41'x12' Deck
14'x14' Gazebo

PLAN TO ACCOMPANY APPLICATION
FOR BUILDING PERMIT

**LOT 14
FRIENDSHIP FARMS**

ZONING: 'RR'
TAX MAP No. 15 GRID 17
THIRD ELECTION DISTRICT
HOWARD COUNTY, MARYLAND
JANUARY, 2001 PLAT #13643
SHEET 1 OF 1 SCALE 1"=50'

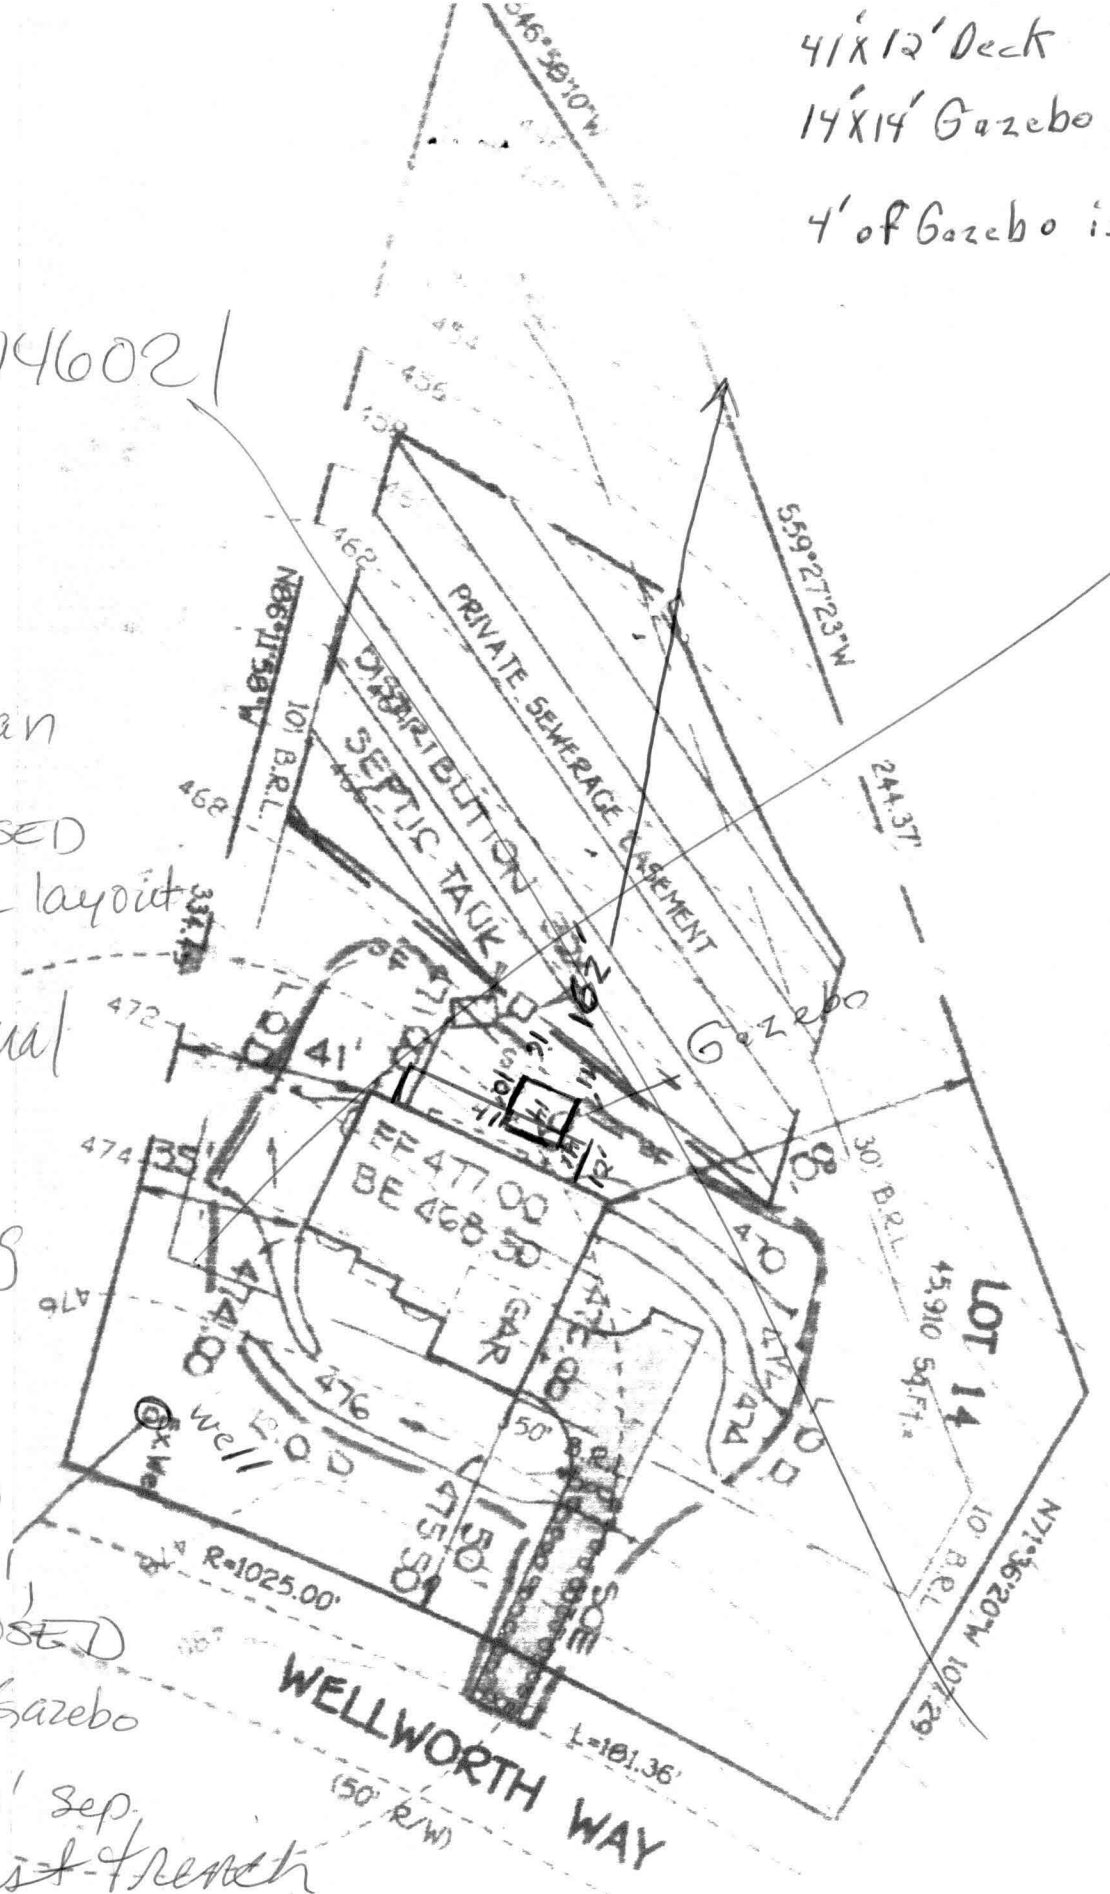
4' of Gazebo is on deck

This plan shows proposed septic layout

NOT Actual Layout.

According to our permit diagram on 7/10/01 the proposed Deck & Gazebo

OK - 20' sep. to closest trench & s.t. ACTUALLY Further.
